Donald C. Cook Nuclear Plant Unit 1 and Unit 2
REVISED RESPONSE TO REQUEST FOR ADDITIONAL INFORMATION
REGARDING RELAXATION OF REACTOR PRESSURE VESSEL HEAD
PENETRATION INSPECTION REQUIREMENTS IN NUCLEAR
REGULATORY COMMISSION ORDER

ATTACHMENT 1 TO AEP:NRC:3054-08

REVISED RESPONSE TO REQUEST FOR ADDITIONAL INFORMATION

ATTACHMENT 3 TO AEP:NRC:3054-08
CRACK GROWTH CURVES

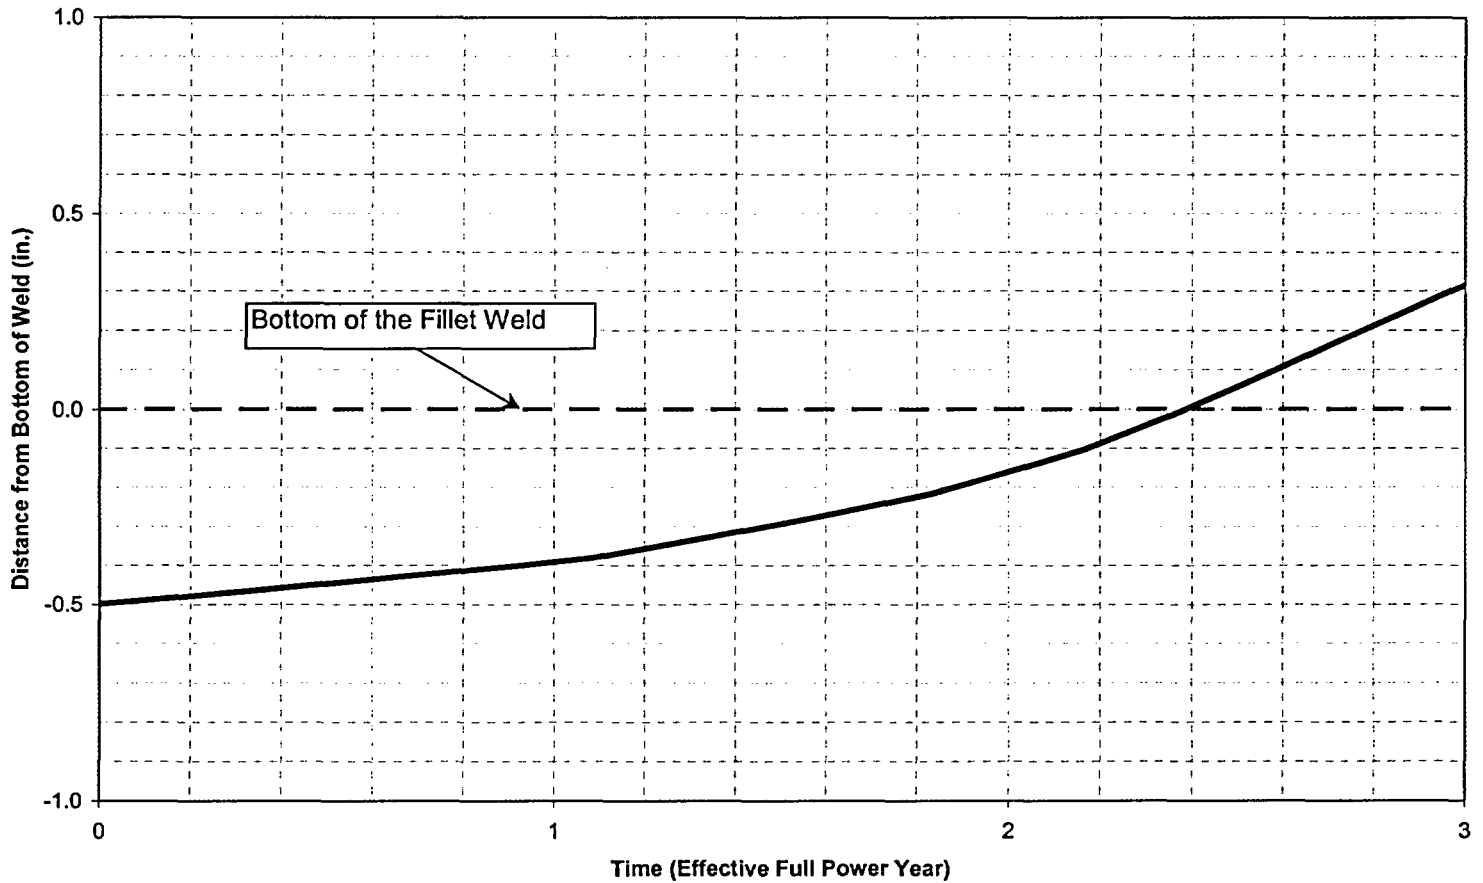
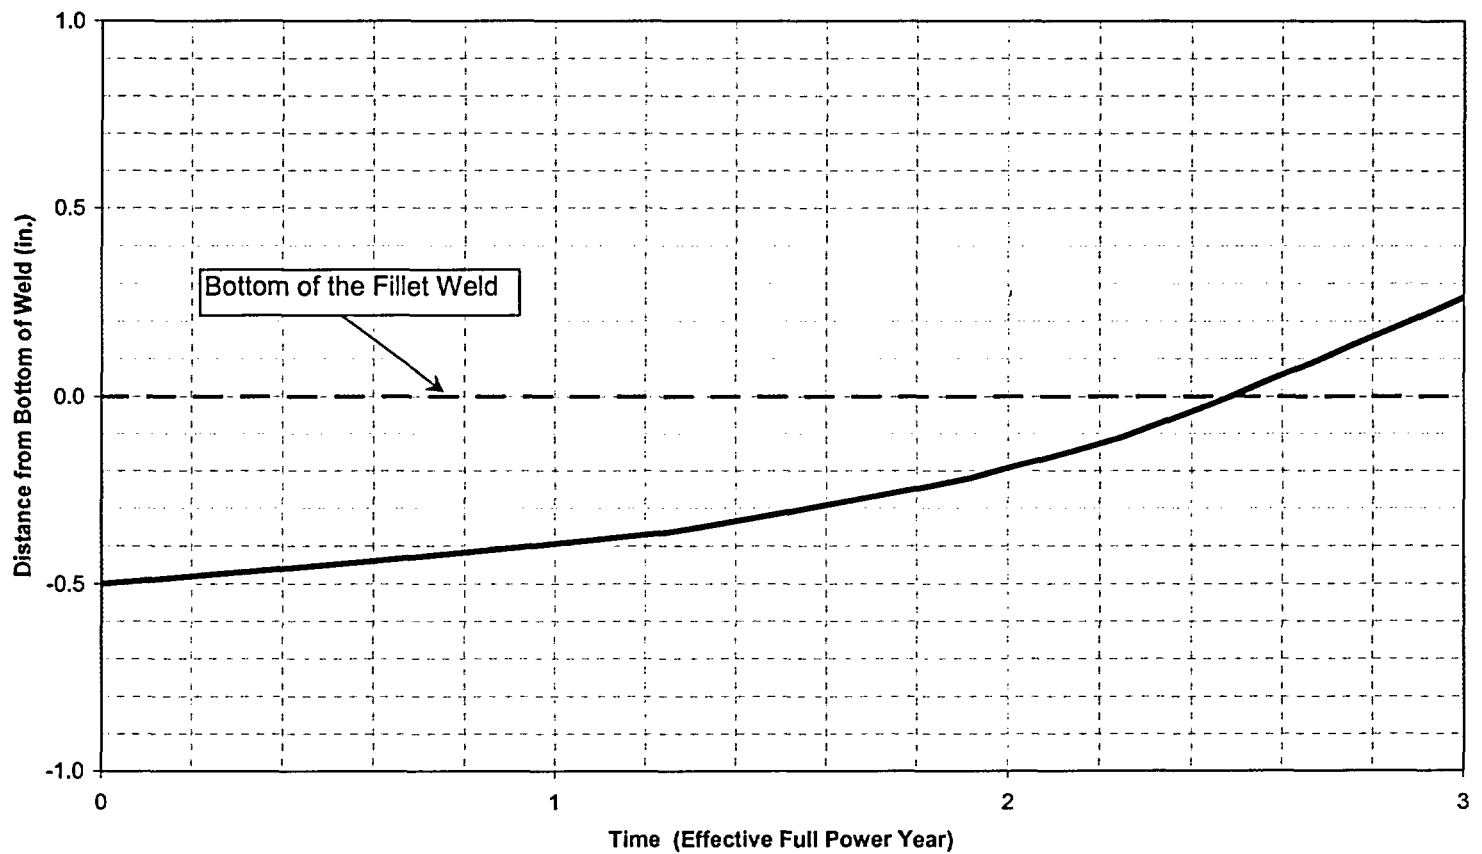
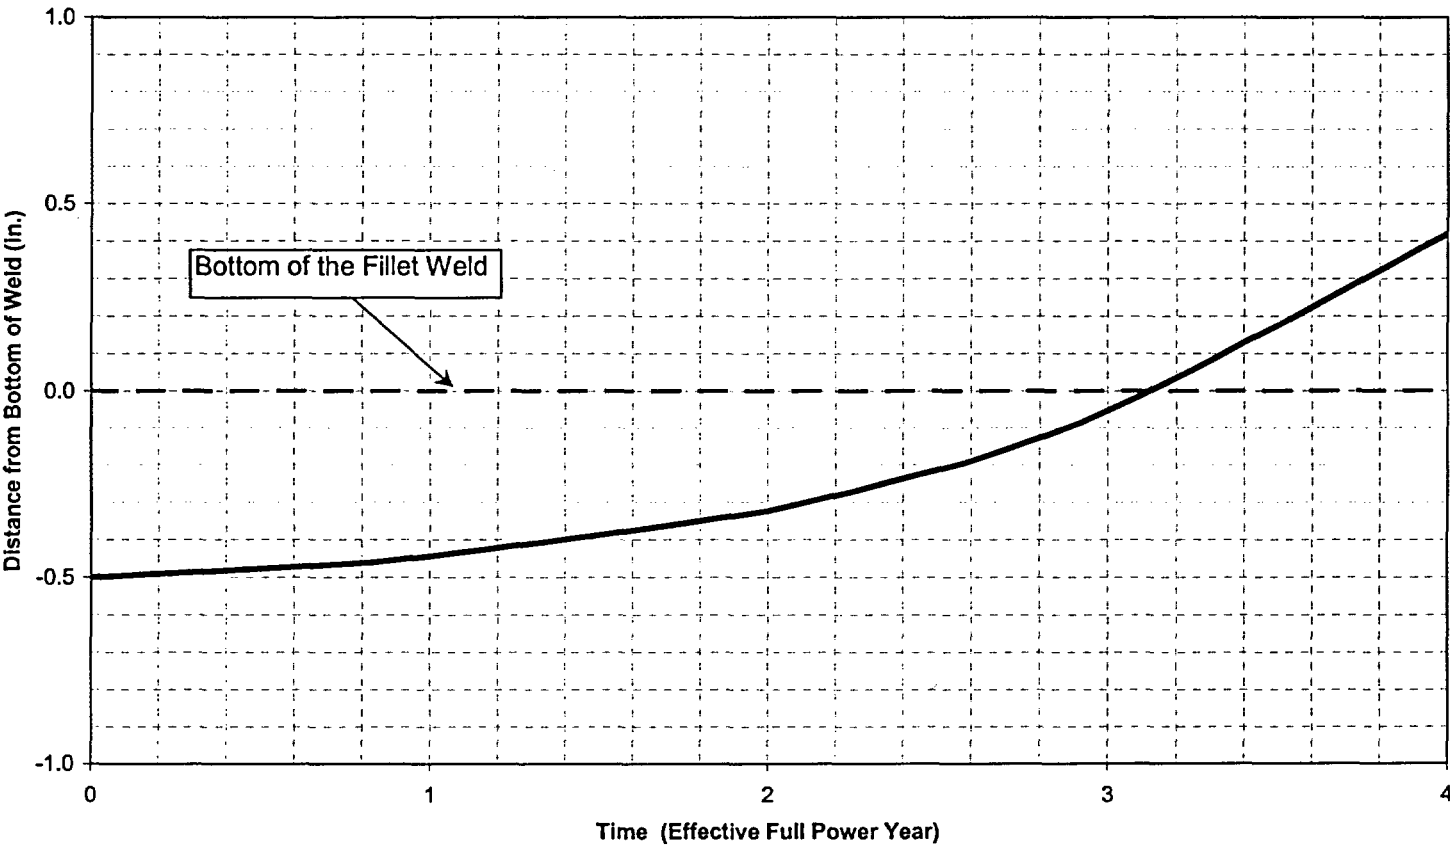
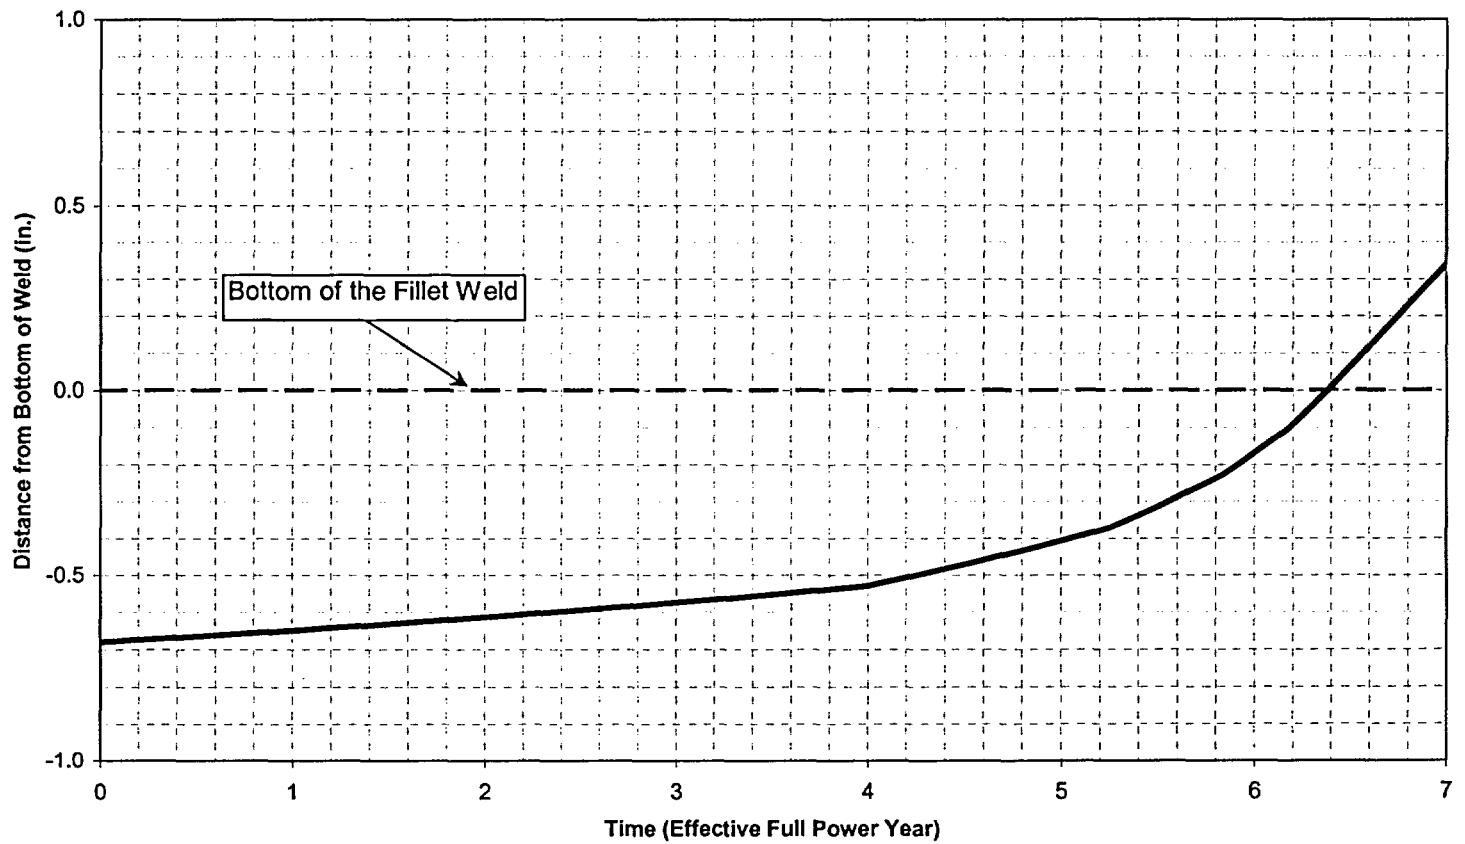
Provide additional technical justification (i.e., operating stress levels, crack growth analysis, etc.) that supports the licensee's statement that the small area that cannot be scanned is insignificant to the phenomena of concern.

Why is the postulated flaw given a depth of 80 percent of the wall thickness instead of 100 percent of the wall thickness? The former does not appear to be conservative.

The calculations were performed for the three outer penetration rows (45.8°, 47.0°, and 50.5° in Attachment 2). The results of these calculations are illustrated by the four crack growth curves provided in Attachment 3 to this letter. The first three curves show that it would take more than 2.3 effective full power years for the postulated flaw 0.5 inches below the J-groove weld to propagate to the bottom of the weld. This time period is more than the minimum under-head inspection interval for Unit 2 (one operating cycle) required by NRC Order EA-03-009. For rows other than the three outer rows, the inspectable length exceeds 1 inch, based on best estimates by personnel reviewing ultrasonic inspection results. The 1 inch inspectable length provides a conservative factor of 2 with respect to the crack growth distance assumed in the calculations. The effect of additional inspectable length on crack growth times is illustrated by a comparison of the first and fourth curves in Attachment 3. These curves show that an increase in inspectable length of 0.18 inches results in an increase of approximately 4 effective full power years in the time it would take a flaw in the uninspectable area to reach the J-groove weld for the third outermost row.

In the crack growth calculation described in Reference 6, the flaw was postulated to be 80 percent through the nozzle wall, since this is the maximum value given in Table A-3320-2 in Appendix A to Section XI of the American Society of Mechanical Engineers Boiler and Pressure Vessel Code. However, a flaw depth of 100 percent was assumed in the above described crack growth calculations.
